# Product Change Notification (PCN)

PCN Number	505462	Date Issued	September 07, 2018
Reason for Change	Change to Product		
Change Type Description	This letter is to inform you that changes are being made to the part(s) identified in this Notice. The change may affect the fit, form, function or appearance of the parts, or it may result in a change to the specification. The pictures below show an example of the possible differences.		
Reason for Short Notice	Corrective Actions		
Assessment of Change	First article inspection		
Internal Molex Qualification Date	April 10, 2018		
Sample Availability Date (Changed Part)	April 10, 2018		
Planned Implementation Date	September 30, 2018		
Method of Identifying Change	Date code

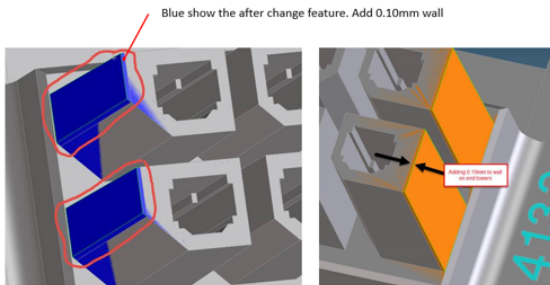
- Add 0.10mm wall

- To reduce the risks of receptacle housing is not guided into full alignment during mating process due to dimensional sizing of parts and/or angle mating and it will cause receptacle housing tower end have stubbing issue when mating.
- Product Impact
  - There is dimension change to the product as the picture.
- Part Number Impact
  - This change will impact to 44133-XX00, 12CKT-24CKT
- Qualification Reports and samples available upon request after the date shown above
